**CIRCULAR FRAME (RING)
AND COVER**

STANDARD PLAN B-30.70-04

**SUPPLEMENTAL TO STANDARD PLAN
B-30.70-04**

**BLIND PICK NOTCH
DETAIL "A"**

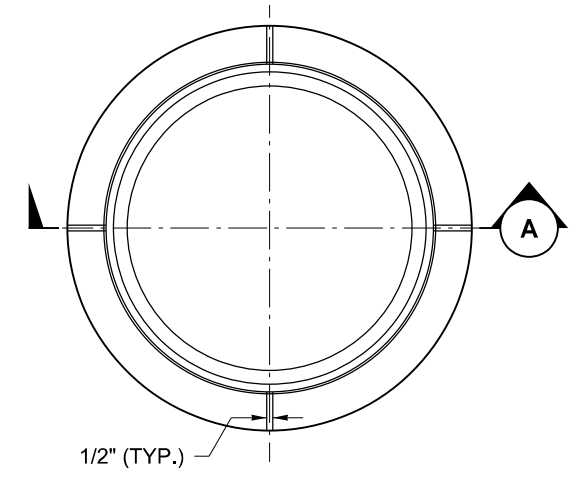
1. Manhole covers shall have double 1" pick holes. The pick holes shall completely penetrate the cover.
